# Corbett School Seismic Review

February 6, 2013

Re: Corbett School Seismic Review  
Corbett School District  
Corbett, Oregon

<p><b>Associated Consultants, Inc.</b> Structural Engineers</p> <p>100 East 13th Street • Suite 10 • Vancouver, Washington 98660 Portland: (503) 384-0460 • Vancouver: (360) 699-0607</p>	Project	Corbett School	Job No.	13-109
	Location	Corbett, Oregon.	Date	01-18-13
	Client	Rommel	Sheet No.	11

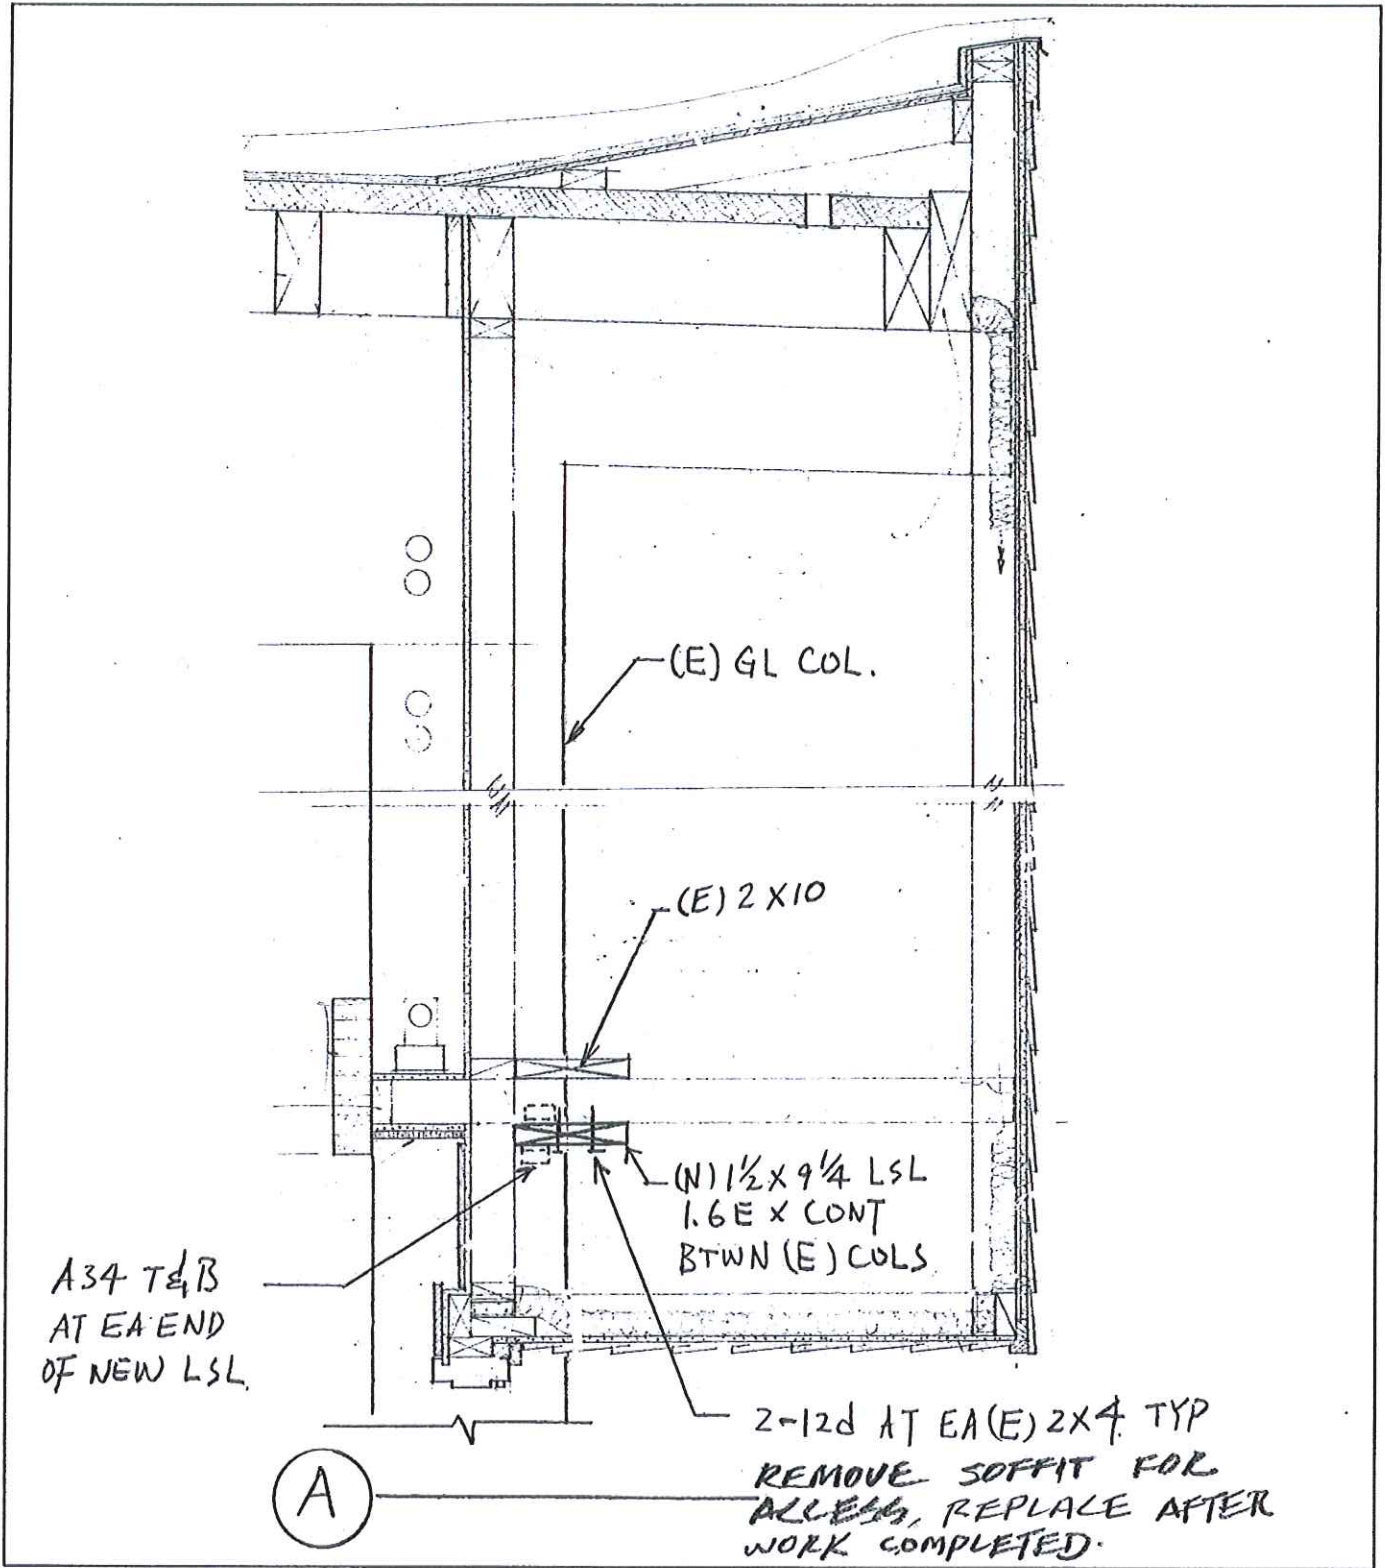
Framing around the windows consists of glue-lam columns which supports the roof beams. At mid-height there are glue-lam beams which are hung from the inside edges of the columns. These beams provide lateral support for the wall above the windows as well as creating a niche for lighting fixtures. The beams are inadequate for wind support and reinforcing is required. For repair we believe the exterior soffit above the doors and windows may be removed to install a new 2x10 (Select Structural DF) or 2x10 Timber Strand LSL at the bottom of the existing 2x4 framing per attached detail 'A' .

<p><b>Associated Consultants, Inc.</b> Structural Engineers</p> <p>100 East 13th Street • Suite 10 • Vancouver, Washington 98660 Portland: (503) 384-0460 • Vancouver: (360) 699-0607</p>	Project	Corbett School	Job No.	13-109
	Location	Corbett, Oregon.	Date	01-18-13
	Client	Rommel	Sheet No.	12

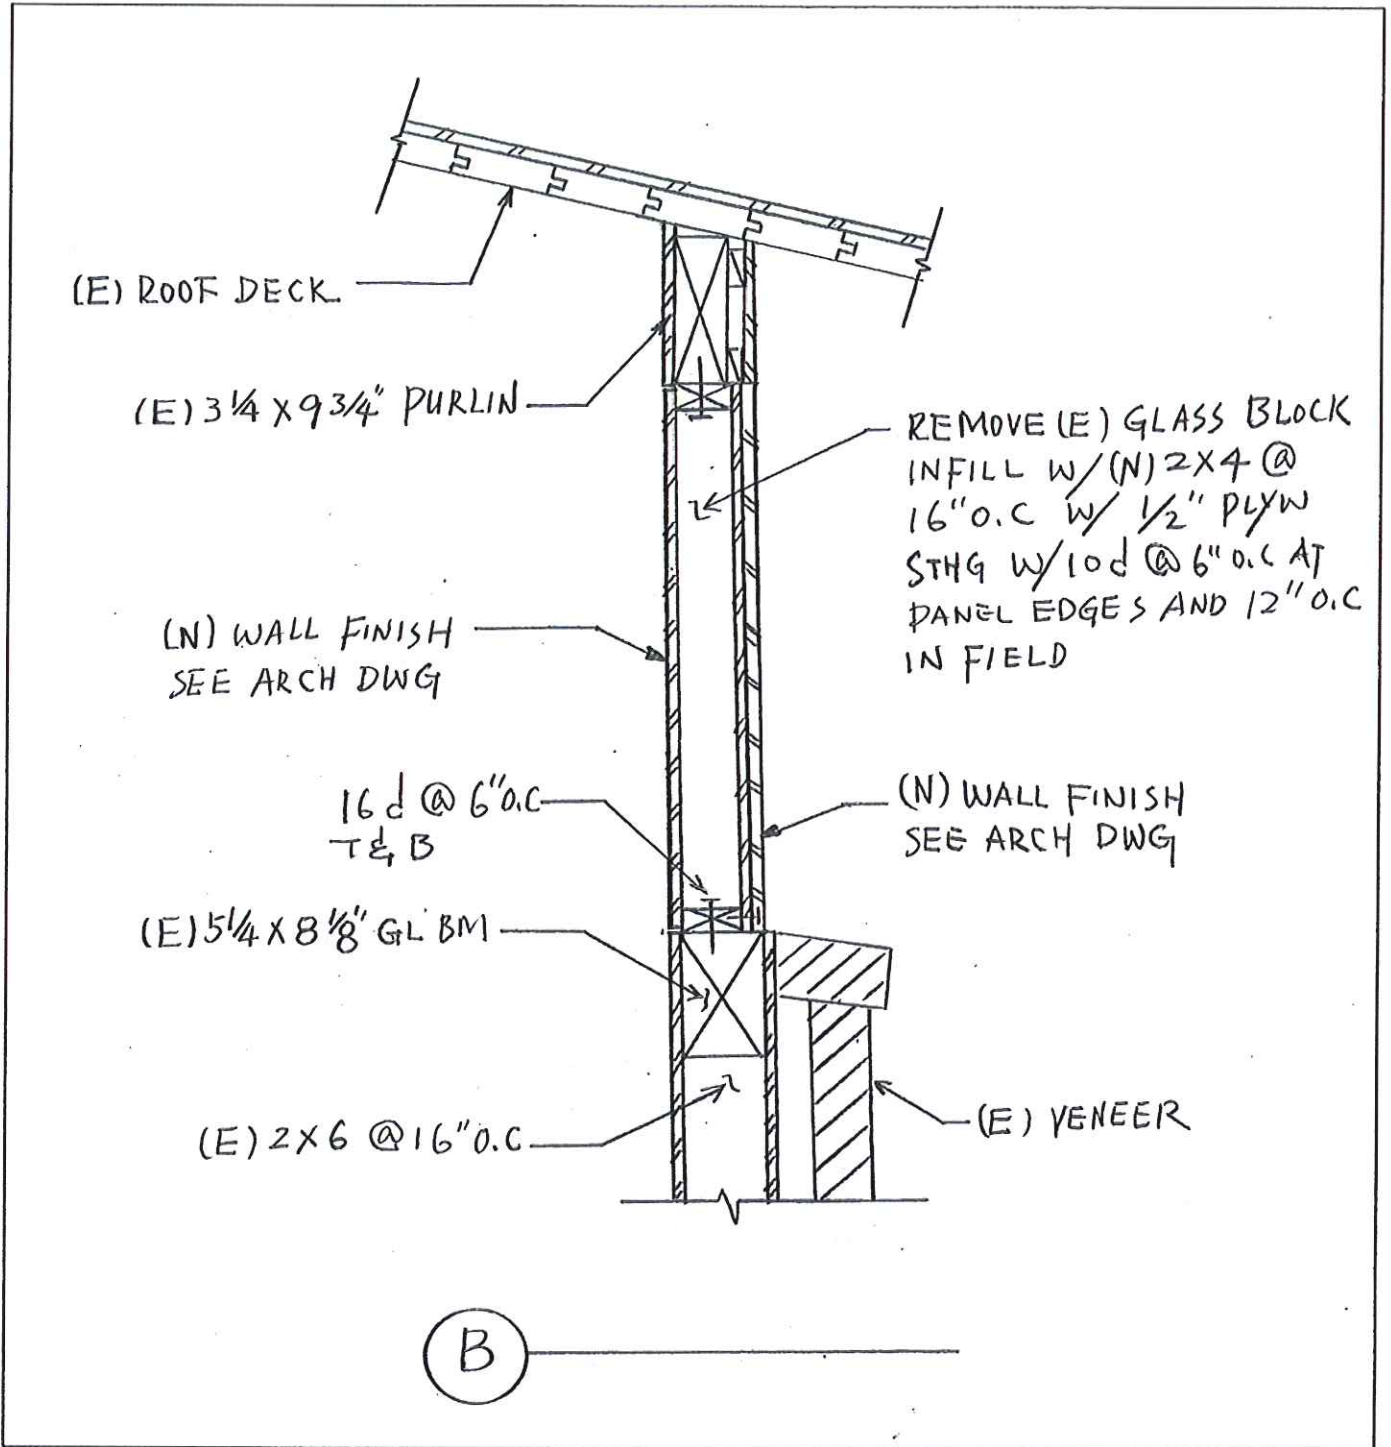
Our review of the drawings determined that the building is structurally satisfactory for gravity loads. At the east and west sides there are sections of glass blocks at top of walls which cause discontinuity between the roof diaphragm and the shear walls below the glass block panels. We recommend removing at least two bays of glass block at each wall and infilling with studs and plywood per attached detail 'B'

Vertical load supporting elements appear to be structurally satisfactory. The walls have adequate strength to support earthquake and wind loads, however the shear path from the existing roof diaphragm to the shear-wall at the west side of the corridor is lacking. We recommend installing new 1/2" plywood, per attached detail 'B', on the face of the pony wall, from the ceiling framing to the underside of the roof above that wall.
